CCC Interrogatory #1

Reference: Ex. H1/T1/S1

Figure 1: Average Rate Regulated Hydro Output by Hour

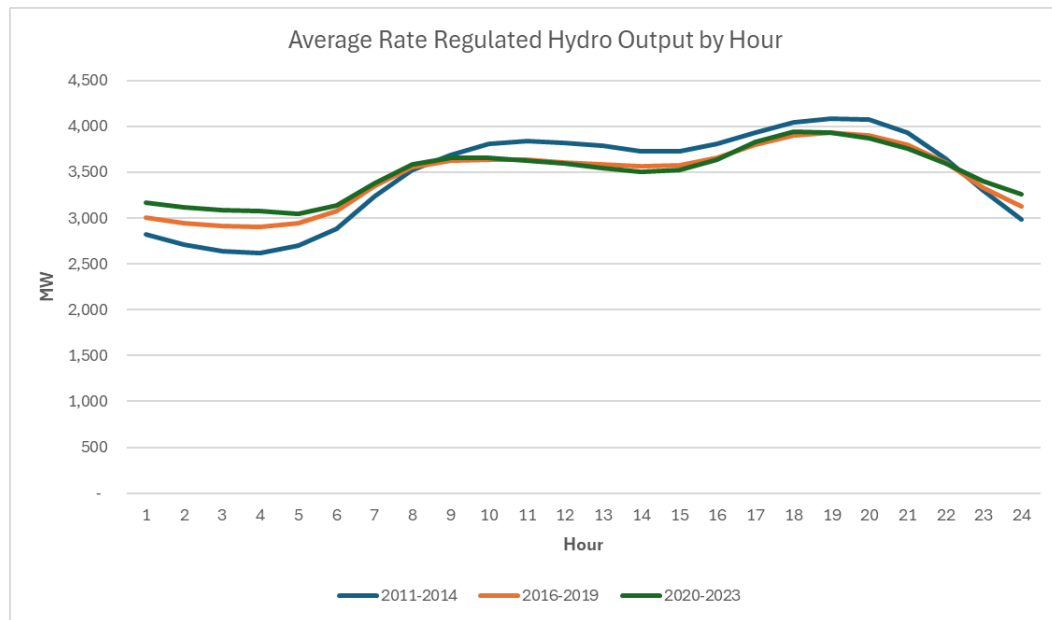
4 (b) Please explain why OPG time-shifted its output for its regulated hydro assets
5 less in 2016-2019 versus 2011-2014 (as shown by the flatter curve in the top
6 figure). Please enumerate all causes. Please also describe any differences
7 arising in 2020-2023 versus previous periods, enumerating all the differences.

- a) OPG has provided the requested charts, reproduced using IESO data as Figures 1 and 2 below.¹ A line for 2020-2023 has been added. In addition, OPG has provided the Regulated Hydroelectric output shown in Figure 1, further split into the categories of “Baseload and Run-of-River”, “Intermediate” and “Peaking” facilities. This breakdown is necessary to accurately analyze the changes in time shifting for the regulated facilities between time periods and between the regulated and the unregulated hydroelectric facilities. The “peaking” category includes the PGS.

b) As shown in the Figures provided in part (a), the difference in time shifting of energy for the regulated hydroelectric facilities between the periods is primarily driven by the baseload facilities, in particular the Sir Adam Beck Generating Stations (“SAB 1” and “SAB 2”). Period over period differences in OPG’s time shifting observed for the baseload facilities between the 2011-2014 period and 2016-2019 period are primarily attributed to water flow conditions, with higher water flow limiting OPG’s ability to time shift generation. The 2020-2023 period is similar to 2016-2019.

Figure 1: Average Hourly PGS Generation

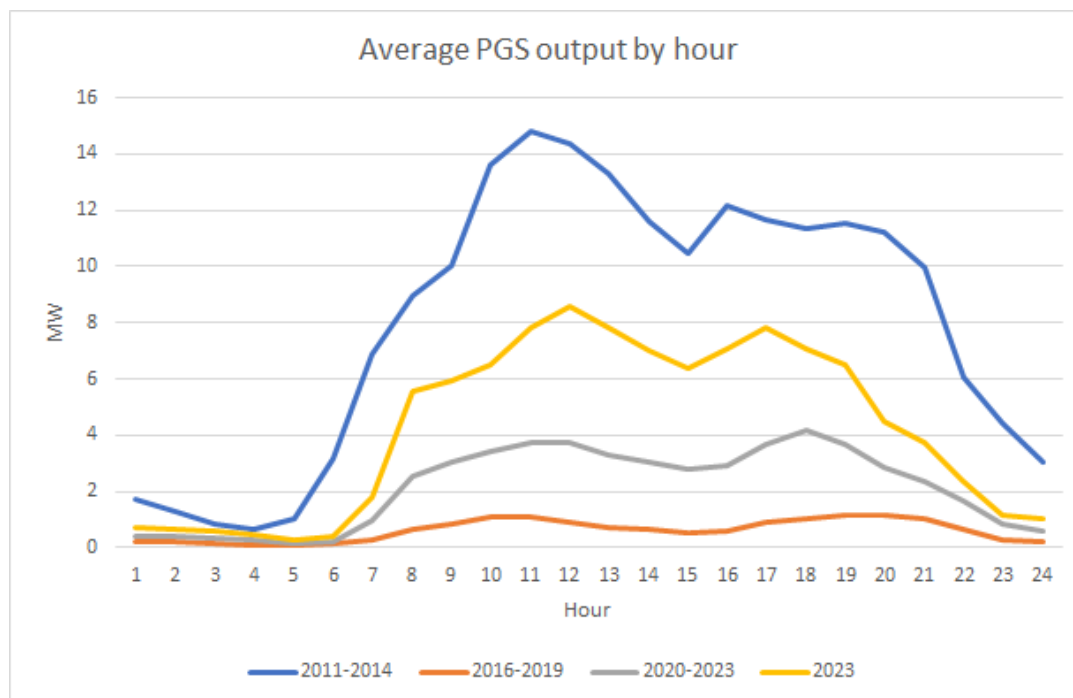
- (a) Please reproduce the above figure adding a line for 2020-2023.
- (b) What percent of the decline in PGS output from 2011-2014 to 2020-2023 (if any) was due to water levels?
- (c) What is the demand (MW) of the PGS pump running at full capacity?
- (d) What is the generating capacity (MW) of the PGS generator running at full capacity?
- (e) What is the GRC for power generated from the PGS?
- (f) What production did OPG forecast for the PGS for 2020 to 2023 in its last payment amounts application?
- (g) What production is OPG forecasting for the PGS for 2025-2026?

- a) Figure 1 has been reproduced using IESO data and a line for 2020-2023 has been added. OPG has also added a line for 2023 to illustrate PGS generation with the lower flows on the Niagara River observed in 2023 as discussed below.
